ADDENDUM NO. 1

RE: Dumpster Fork Pockets RFQ-5658-25-KN

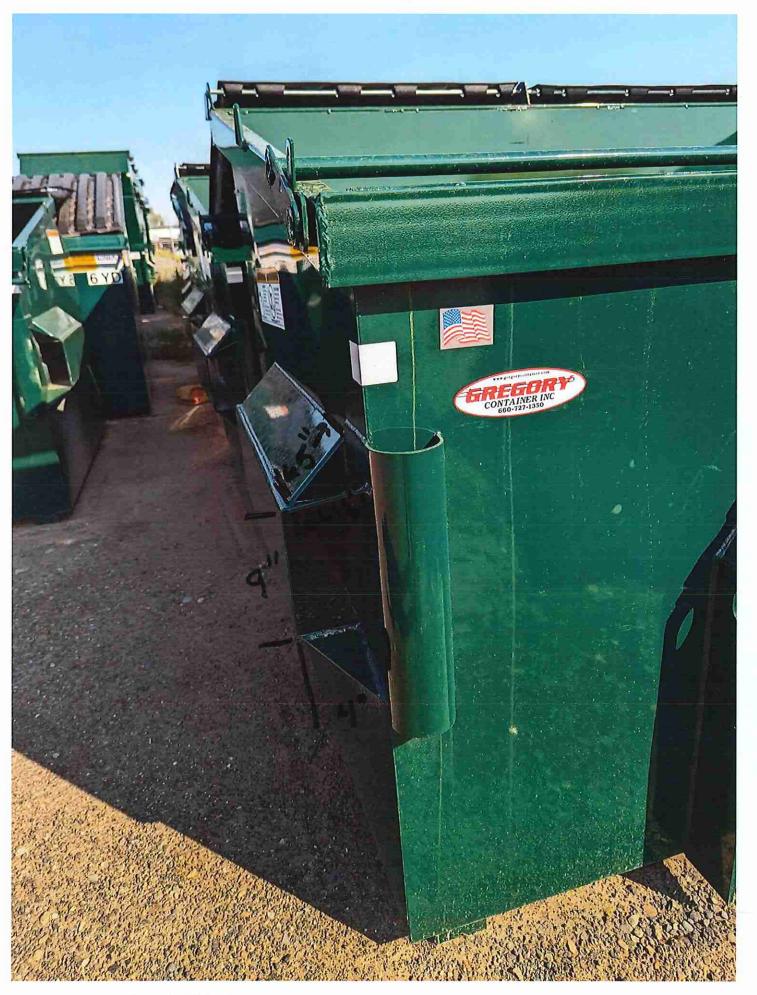
1. **Q:** If there are drawings for the fork pockets with specific dimensions? We cannot seem to find any drawings if there are any tied to this project.

2. **Q:** Is this a one size fits all application? I see the given fork dimensions in the rfq, but need to know if there are different lengths needed?

We are curious the exact dimension needed per fork pocket. Assuming the overall length would need to be LESS than the given fork length and the height/width would need to be MORE than the given dimension? If so, total quantities needed as well, to determine cost and shipping cost.

3. **Q:** As a career welder, fabricator and manufacturer of over 40 years I highly suggest not to galvanize the fork pockets. Two reasons why, one it is difficult to weld a galvanized piece of metal and expect the weld to have the correct strength or the person welding it would have to grind off the galvanization in order to weld it. Two, welding anything galvanized causes a very toxic environment and the welder would need to wear a separate air supply as to not breathe the fumes created by welding the galvanized metal and it will still need to be painted. My solution to this is, if we win the bid, we have a paint that is nontoxic and our customers have compared it to being better than Caterpillar paint. We can match any color. Of course, it would be an additional charge, but it is more affordable than galvanizing. Please see the attached picture. Is this what you are expecting? Are these guests acceptable?

- 4. **Q:** Do the gussets need to be fully welded to the pocket for delivery, or do they just need to be provided and the customer will weld the gussets on when the pockets are welded to the dumpster? Fully welding the gussets after the pocket is attached to the dumpster is our procedure to prevent warping and twisting of the pocket.
 - **A:** The City staff will be doing all installation / welding. This is a product purchase only.
- 5. **Q:** We intended on submitting a bid for the dumpster pockets, the specs call out for a galvanized finish to help prevent rust, however in our experience that makes welding them an unpleasant event. Is there another finish that is acceptable such as powder coat primer? **A:** The City is adjusting the original request. We do not want galvanized steel.

A: Please use the dimensions in the pictures provided below. We don't have any other drawings.

A: This purchase is for one size fits all pockets. Please use the dimensions in the pictures below.

A: The City is adjusting the original request. We do not want galvanized steel. The City staff will be doing all installation / welding.
